**ON-SITE SEWAGE DISPOSAL SYSTEM  
HOWARD COUNTY HEALTH DEPARTMENT  
BUREAU OF ENVIRONMENTAL HEALTH**

**04-331397**

SITE INSPECTION SHEET

PROPOSAL: DETACHED GARAGE PROPOSED (- SEE ATTACHED FOR TOPO House built 1957)

LOCATION DIAGRAM

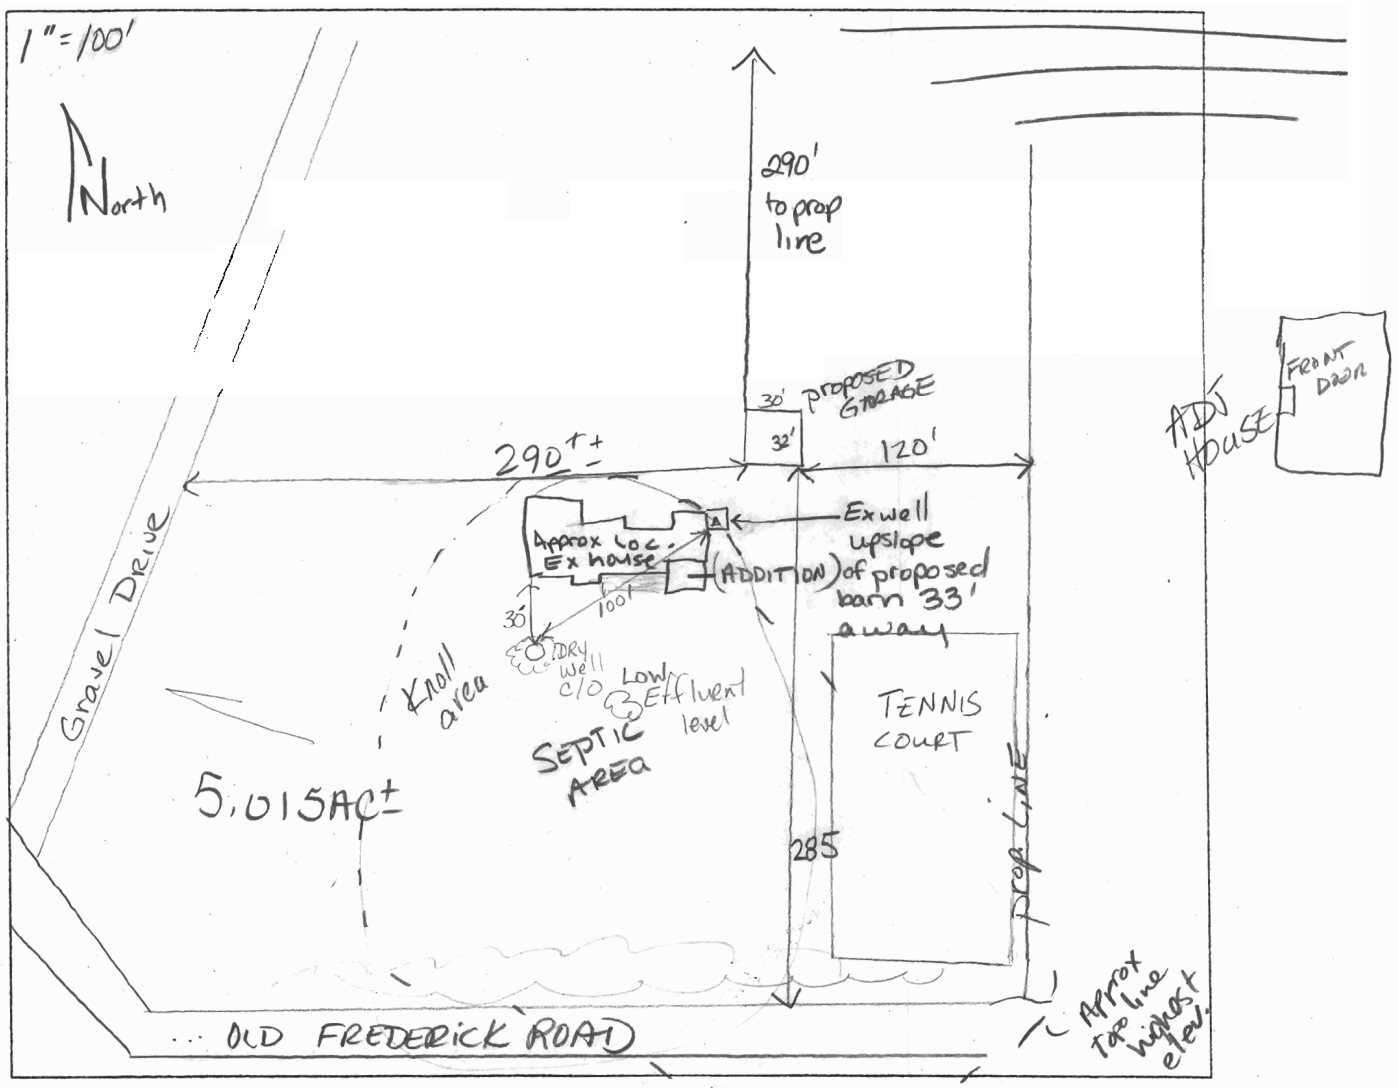
COMMENTS: 5/12/04 Proposed Garage not proposed in future - avail septic repair area due to ex well location. JB ok'd signing BPO0147910 but to get soil profile via auger. 5/15/04 pumped out dry well ≈ 2yrs ago

5/15/04 - Recently pumped. DRY well level low. Plenty SEPTIC AREA AVAIL. - Generally soil
